NEDO-21061

NRC QUESTIONS DATED JUNE 12, 1976, WITH RESPONSES

RESPONSES TO NRC QUESTIONS

Reference Source: Letter with enclosure, "Request for Additional Information, Mark II Containment Dynamic Forcing Functions Information Report (DFFR)," TO E.A. Borgmann, Cincinnati Gas and Electric Company from J.F. Stolz, NRC, dated June 12, 1976.

Figure A4-1. Correlation For Estimating Maximum Pool Surface Velocity

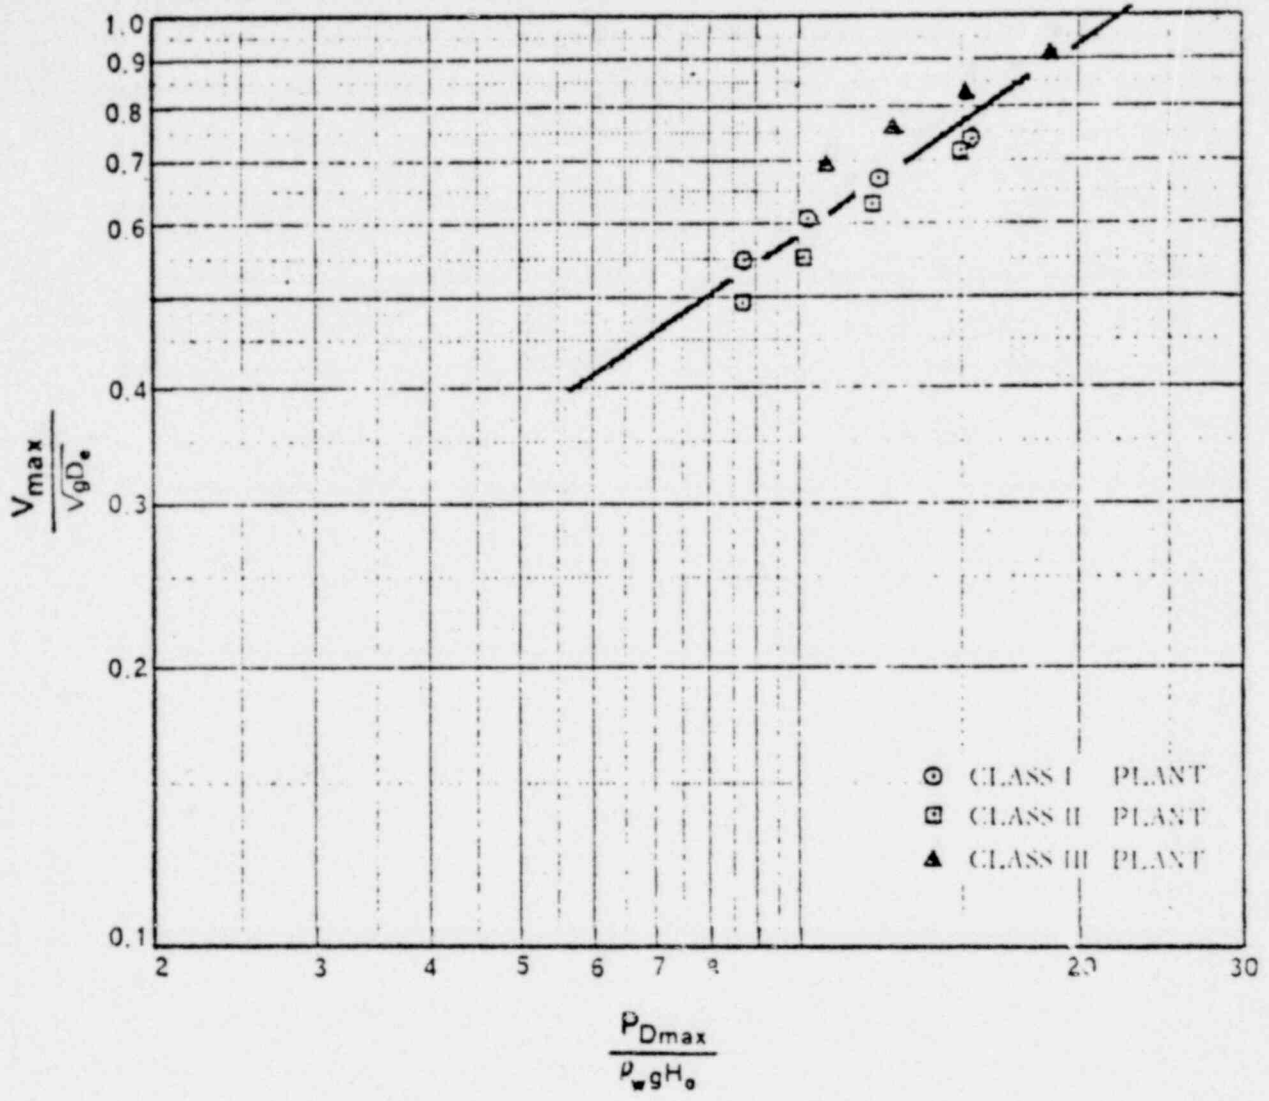
Discuss the manner by which the material in Appendix 4.4 (R2) of the report is to be used. In addition, describe how the data points used to generate Figures A4-1 through A4-3 were obtained.

The following statement has been inserted into Appendix 4.4 (R2) of the report. "The foregoing correlations are not intended to be used in design computations. Rather, the intent of this material is to allow one to be able to make an estimate of the effects of V_{\max} and H_B on the pool swell phenomenon. These estimates are helpful for qualitative assessments of the pool swell phenomenon. The data points used to generate Figures A4-1 and A4-2 were obtained by using the pool swell model at four different submergence depths with all other plant parameters held constant."

Figure 1. Pool Swell Nodel Vent Flow Composition

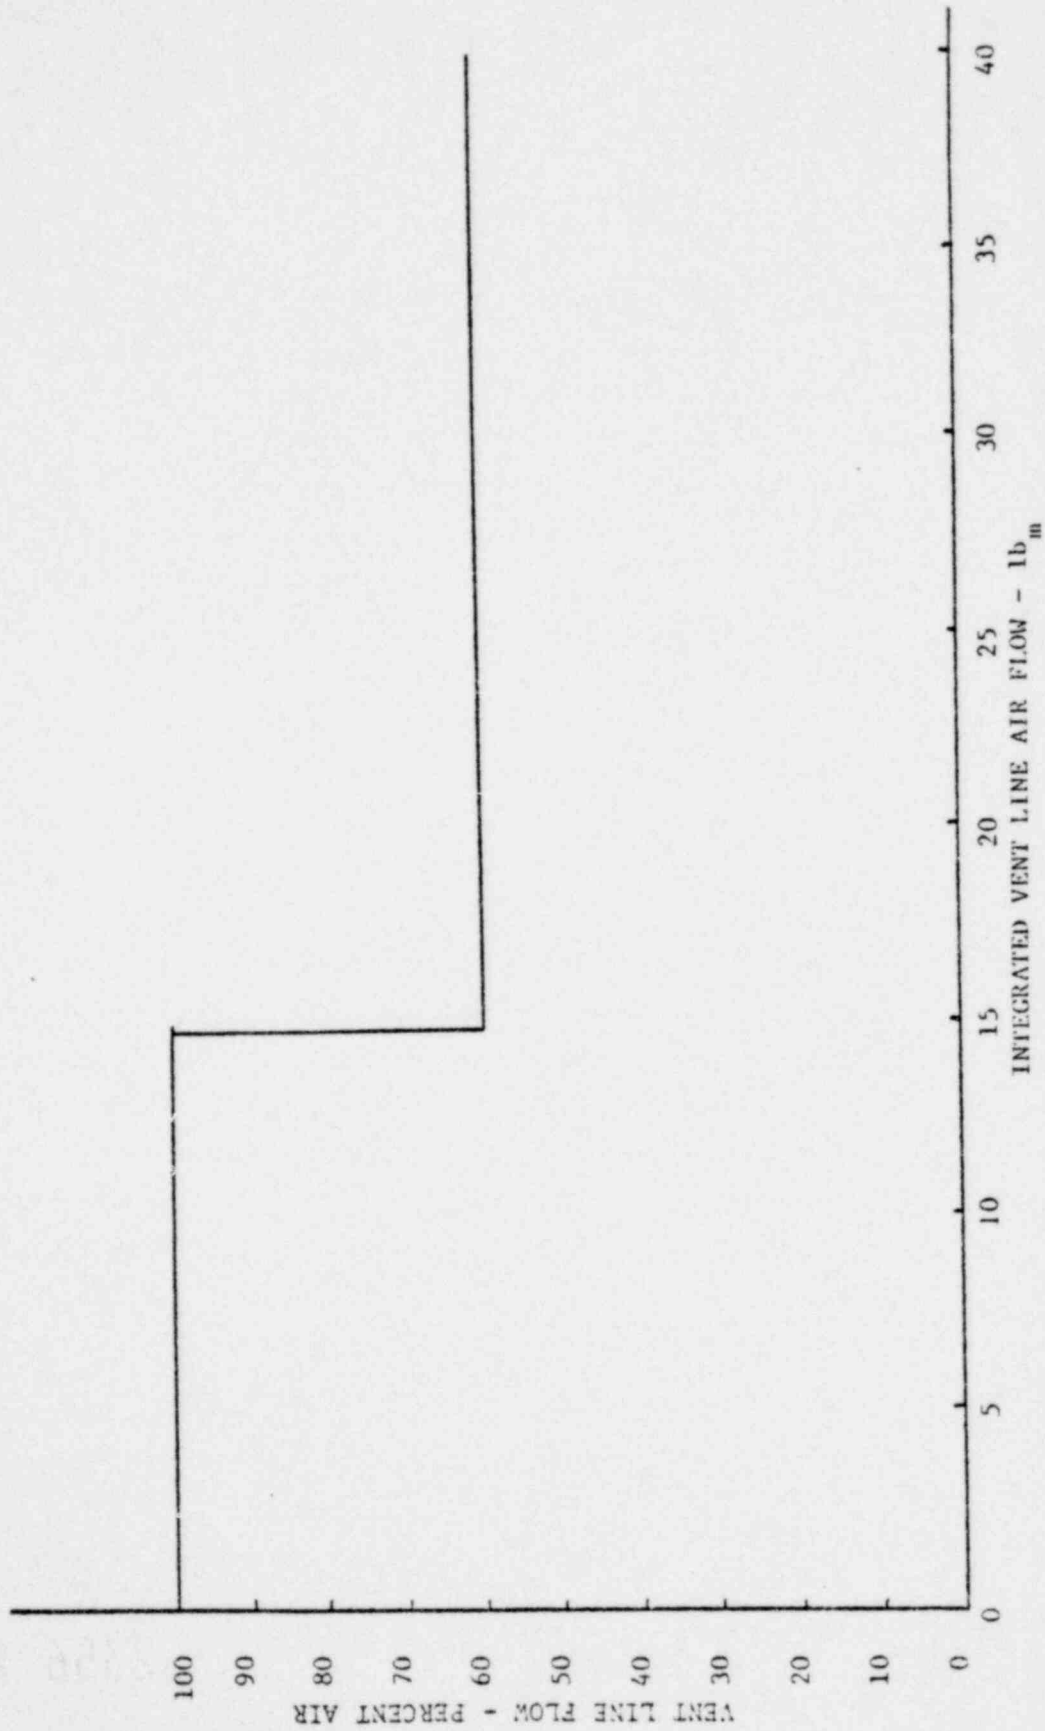
The DFFR provides an analytical evaluation of the pool dynamic loads for Mark II containment. At the April 28, 1976, Mark II meeting dealing with Mark II pool dynamic loads, the Mark II Owners Group stated that the 4T tests would provide experimental confirmation of the analytical methods described in the DFFR. It is the position of the staff that acceptance of the pool dynamic loads by the NRC Staff is contingent on the NRC review and acceptance of the results of the 4T test program and a comparison of the test data with the analytical methods described in the DFFR.

The maximum pool surface velocity as measured in the 4T tests is compared in Figure 1 with the pool swell model predictions. These tests include two blowdown orifice sizes (2-1/2 and 3 in. diameter), two vent diameters (20 and 24 in.), three vent submergences (9, 11, and 13-1/2 ft) and steam and liquid blowdowns. Over this entire range of test parameters, the pool swell model conservatively predicted the maximum pool surface velocity. Therefore, the model can be confidently used in the prediction of pool swell dynamic loads which are dependent on the pool surface velocity.

Figure 2. Effect of Initial Mass of Air in the Vent Line

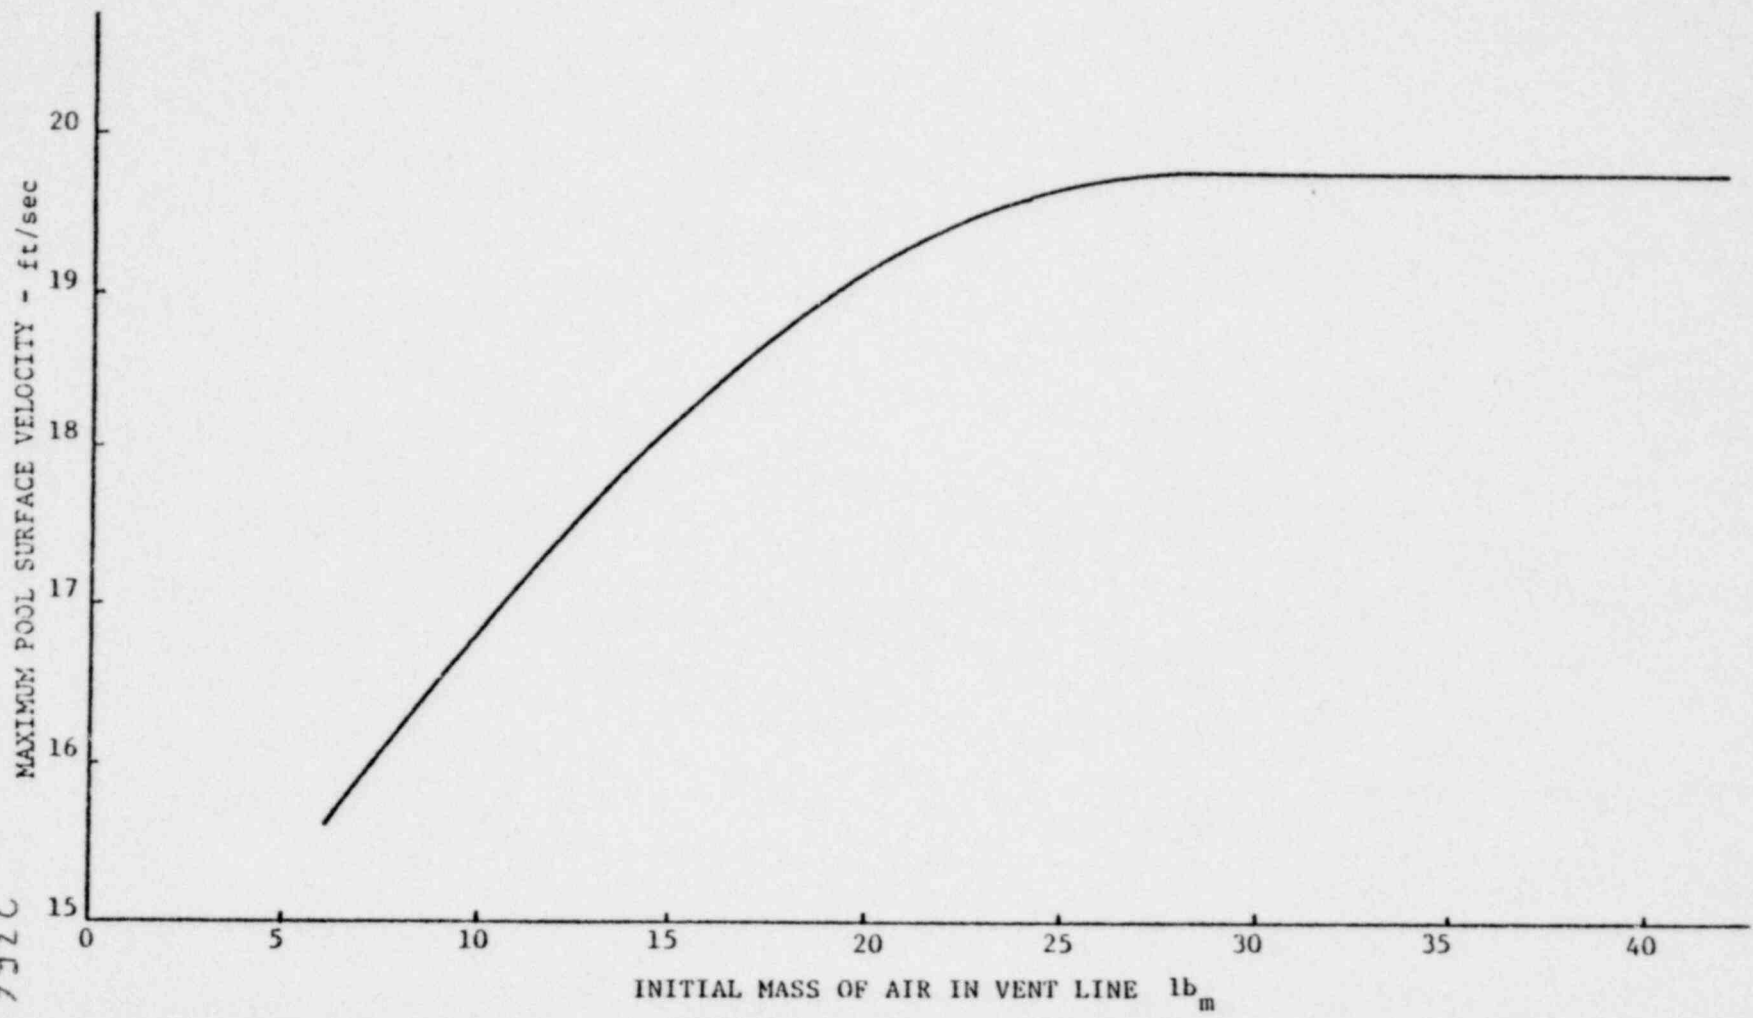
We have not received a detailed description of the test matrix to be conducted for evaluation of the Mark II pool dynamic loads. The description of the 4T test program we have received indicates that 4T air tests have not been covered. In the evaluation of pool dynamic loads for the Mark I and Mark II containment design, air tests were conducted to provide data for some of the pool dynamic loads. Because of the potential for a high air fraction in the vent flow during the early portion of a LOCA, we currently believe that air tests should be conducted as a part of the Mark II pool dynamic load test program.

A study has been conducted with the pool swell model to evaluate the potential effect of additional air flow in the vent line on the observed 4T swell. The composition of the vent flow used in the model is shown in Figure 1. The flow is all-air until the air initially in the vent line (14.8 lbm in this case) is exhausted. Then, the flow is a mixture of steam and air, the relative amount equal to ratio of steam and air in the drywell at the time of vent clearing. As can be seen, if the vent line was longer (i.e., if there was more air in the vent line) the vent flow would continue to be all-air longer. A parameter study was done to examine the effect of more air in the vent line on the maximum pool surface velocity. The results of this study are shown in Figure 2. The actual mass of air in the vent line for the reference test conditions was 14.8 lbm, which resulted in a maximum velocity of 18.2 ft/sec. For continuous air flow, the maximum velocity would be 19.7 ft/sec. This comparison indicates that the difference between the actual test, as conducted with a steam blowdown, and an air blowdown is only an 8% increase in the maximum velocity.

An examination of the air bubble pressure and the times of maximum pool acceleration and velocity help explain why additional air flow has such a small effect. Figure 3 shows the air bubble pressure for several values of the mass of air in the vent line. First, note that all the curves start off the same because initially they all reflect all-air flow, then that the pressure for the condition with the least amount of air begins to decrease first. Notice also, the time at which maximum pool surface velocity is obtained. Any flow, air or otherwise, after this time, has no effect on the maximum velocity; it only retards the water fallback and creates turbulence.
